# **Proposed Changes to B2/AS1**

Report to Building Industry Authority  
November 2003

**Figure 1.1 Examples of Low Risk Masonry Houses**

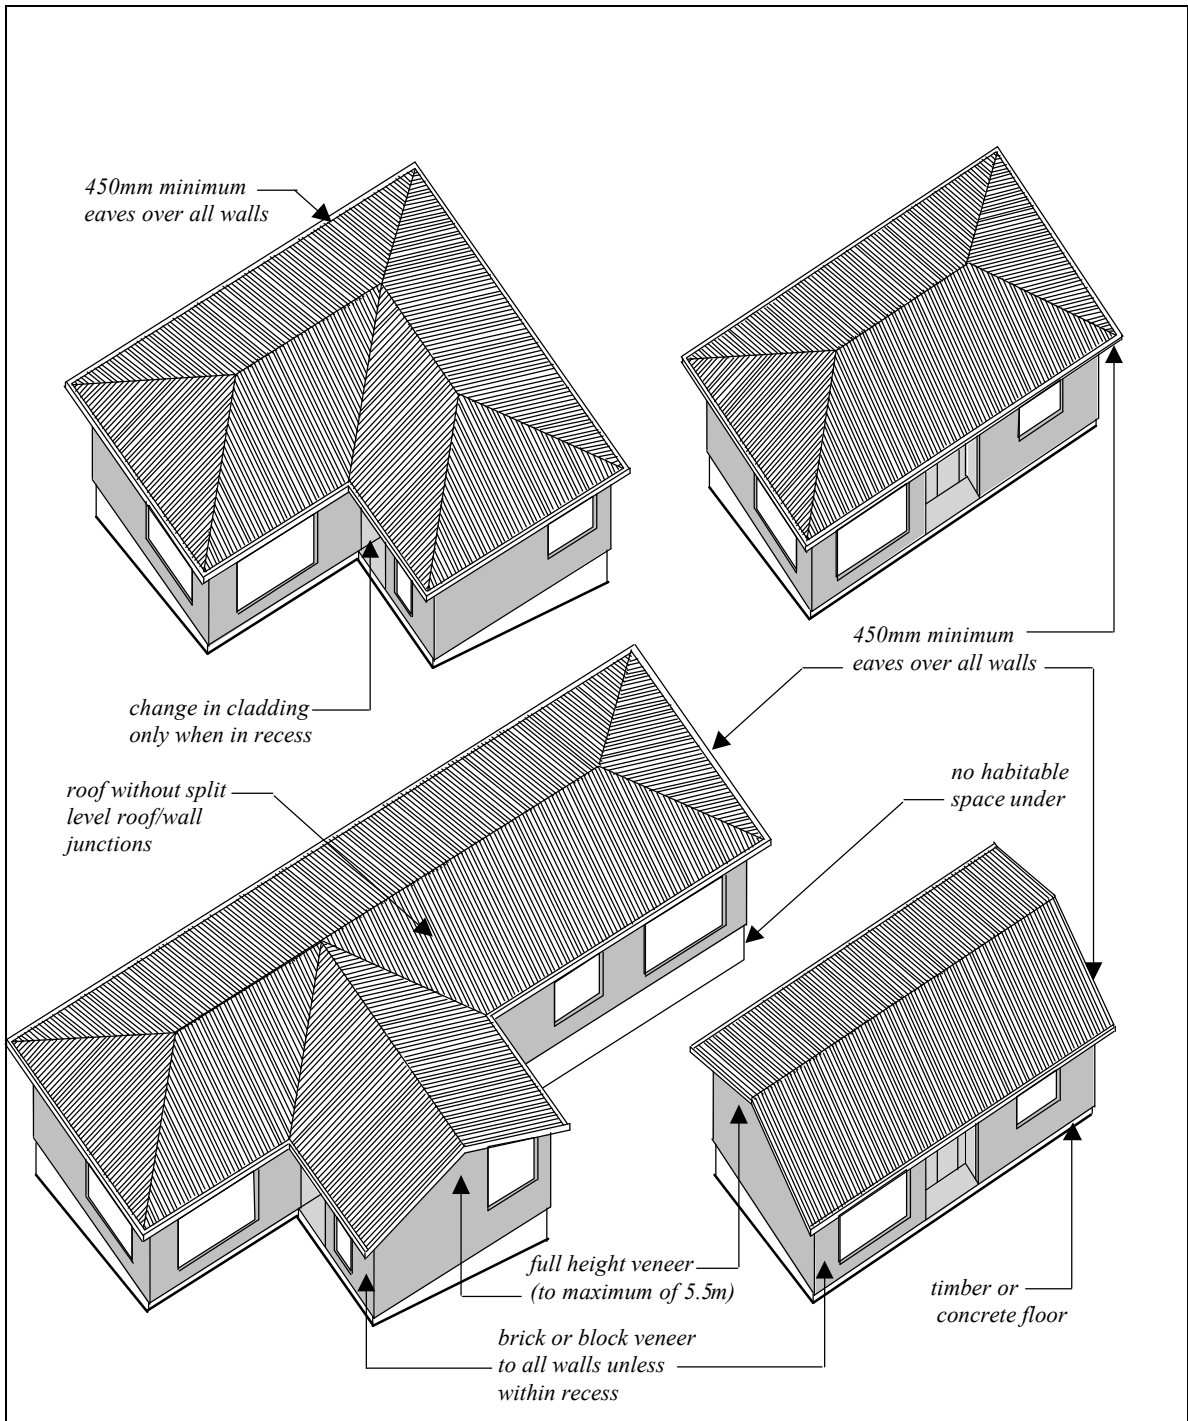
It should be noted that these requirements make no distinction between untreated kiln dried radiata pine and Douglas fir, and that they allow the use of untreated kiln-dried radiata or Douglas fir framing in external walls for houses with masonry veneer cladding, provided they are low risk category – single storey with eaves and no complex features or junctions as shown in Figure 1.1.

Figure 1.2 (a) – Required Treatment Levels for Timber Framing - by Location

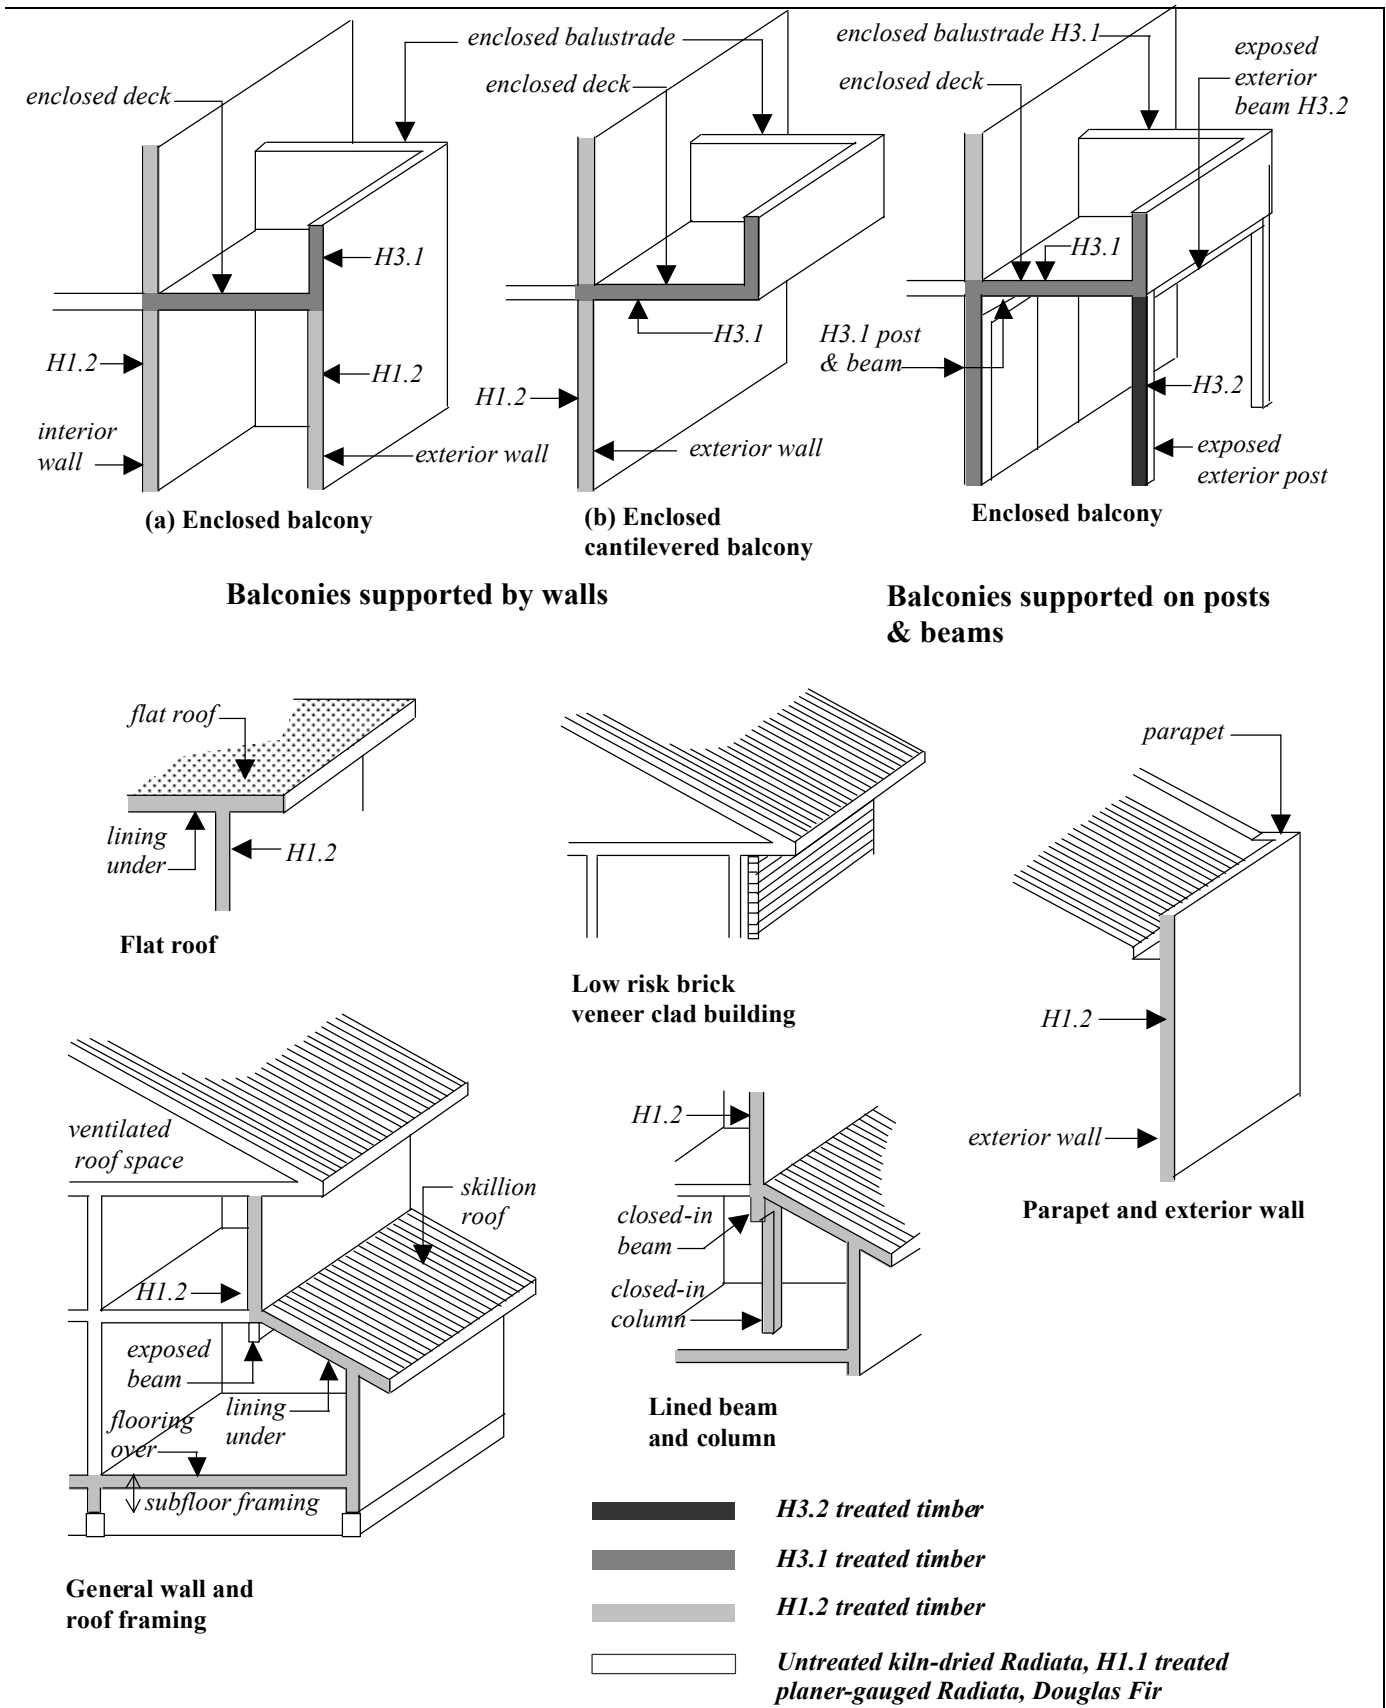
Figure 1.2 illustrates the primary locations of the varying treatment levels recommended in this report.

### **Lowest level of treatment: untreated kiln-dried Radiata, H1.1 treated planer-gauged Radiata and untreated Douglas fir**

- All roof framing, trusses, ceiling joists, blocking and non-structural timber within ventilated roof spaces.
- All inter-storey floor joists, blocking and non-structural timber.
- All interior wall framing including bottom plates and non-structural timber.
- All interior beams, posts, rafters, joists and structural supports that are exposed to the interior on not less than two full sides.
- All exterior wall framing of simple, single storey buildings that are fully clad with masonry veneer, and are classified as low risk as described in NZS 3602.
- Exposed timber framing in unlined buildings such as garages, warehouses, where timber cannot remain wet.

### **H1.2 minimum or equivalent: Pinus species including Radiata Pine**

- All subfloor framing.
- All exterior wall framing of buildings (including boundary joists) other than those allowed within the lowest level of treatment above.
- All enclosed framing, beams and structural supports within skillion roofs.

- All framing of *walls* supporting enclosed decks and balconies.
- All framing within or beneath enclosed parapets.

### **H3.1 minimum**

- All framing within enclosed decks and balconies.
- All framing within enclosed balustrades.
- All enclosed framing supporting flat roofs.
- Enclosed *beams and posts* supporting enclosed decks and balconies
- Other specific enclosed exterior elements such as the framing of boxed chimneys, beams and columns.

### **H3.2 minimum**

- Beams and posts exposed to the weather that support decks and balconies.
